# SUMMARY MINUTES - ADOPTED

## Bicycling and Pedestrian Advisory Committee (BPAC)

### 1. PRESENTATION - FDOT Sunrise Blvd/US 1 Gateway project - Carlos Cejas, P.E. (Vice President), Nelson Mora, P.E. (Senior Project Manager), Gannett Fleming, Inc.

## Existing Pedestrian Travel Operations

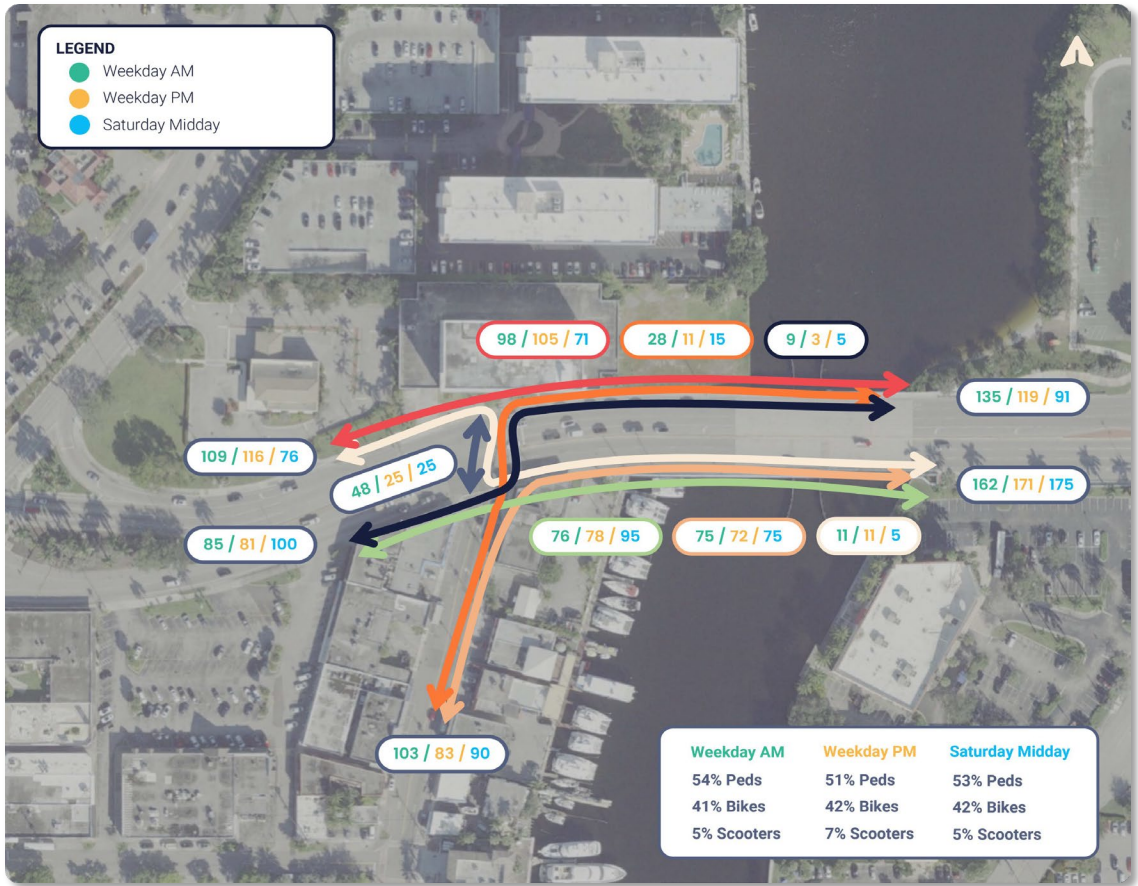
Ms. Forelle commented about the importance of carrying the design of bike/ped facilities through the intersection, not just to the edge. She also commented about considering pedestrian's crossing habits (ex. jay walking) in the design and the need to take a closer look at frequent mid-block crossing locations to determine solutions. The consultant recommended that she also put those comments in writing to the FDOT. Mr. Lim mentioned that he liked the analysis of pedestrian crossing times because it shows that it takes a long time to get across the intersection and how it contrasts with the image of two people "jaywalking" in different directions at a mid-block location.

## Concepts Under Consideration

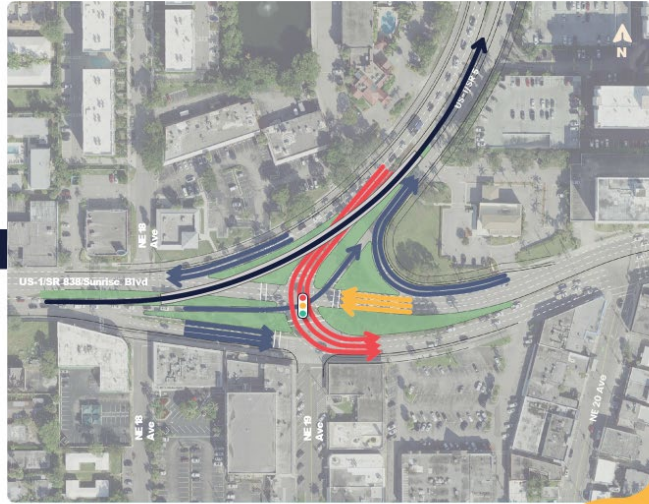
Vice-chair Goldstein asked about roundabouts and mentioned that there is a project to convert one of the roundabouts in Hollywood, Florida into multiple smaller ones. The consultant responded that the facility in Hollywood is too big to be considered a "roundabout" and has multiple lanes. Given the size and ROW available, it is easier to break it up into several smaller roundabouts. In addition, standards require pedestrian crossings to be signalized at multi-lane roundabouts. Bikes and peds do not do well in multi-lane roundabouts.
